### 3.4 Instrumentation and Control

STD DEP T1 3.4-1 (Figure 3.4a, Figure 3.4b, Figure 3.4c)

**Figure 3.4a Safety System Logic and Control (SSLC) Control Interface Diagram**

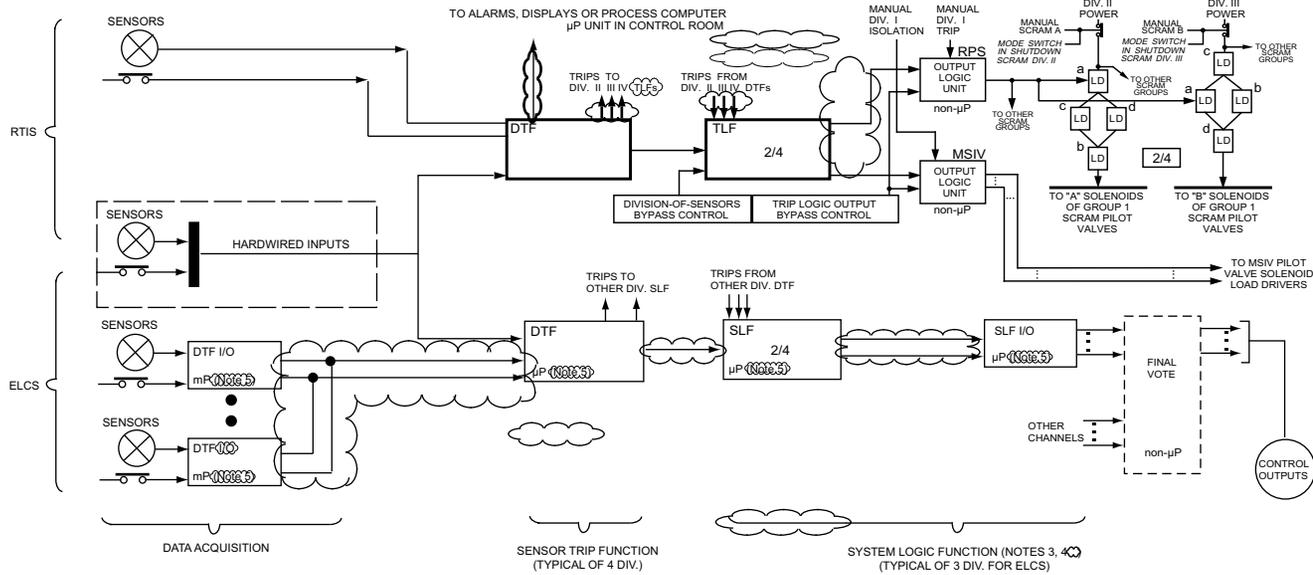
~~The basic hardware functional configuration for one division of SSLC is shown in Figure 3.4b. Each division runs independently (i.e., asynchronously) with respect to the other divisions. The following steps describe the processing sequence and associated function descriptions for incoming sensor signals and outgoing control signals. These steps are performed simultaneously and independently in each of the four divisions:~~

**Figure 3.4b Safety System Logic & Control Block Diagram**

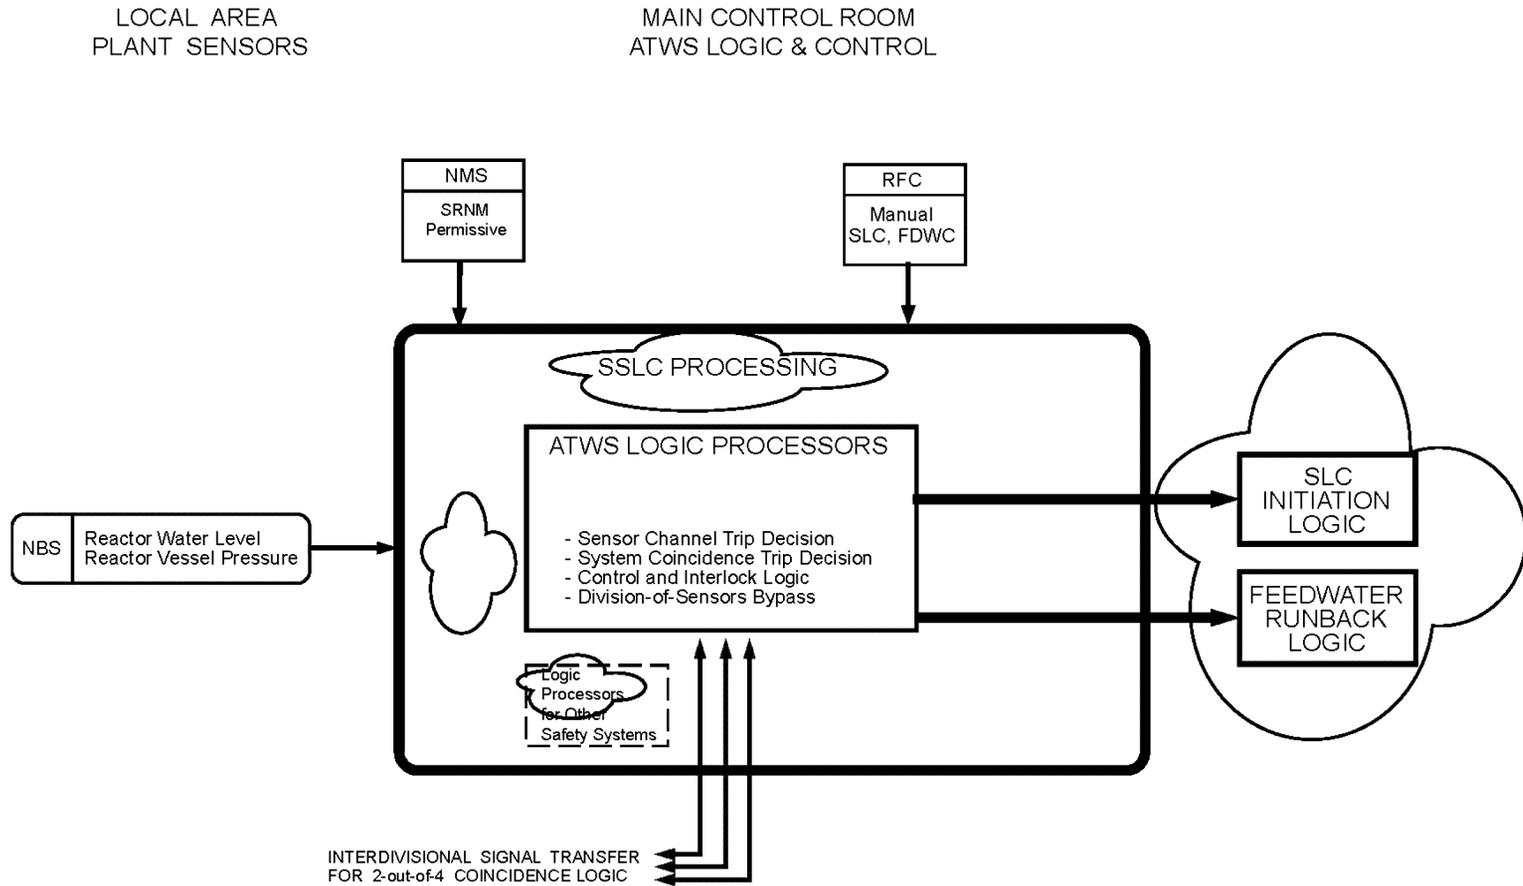
~~As shown in Figure 3.4b, a pair of SLU are located in each of two engineered safety feature (ESF) processing channels, ESF1 and ESF2. ESF1 processes initiation logic for functions which service the reactor vessel at low pressure (e.g. RHR), while ESF2 provides the same support for the vessel at high pressure (e.g. Reactor Core Isolation Cooling (RCIC) System and High Pressure Core Flooder (HPCF) System). Associated LDS and ESF functions are also allocated to these logic channels.~~
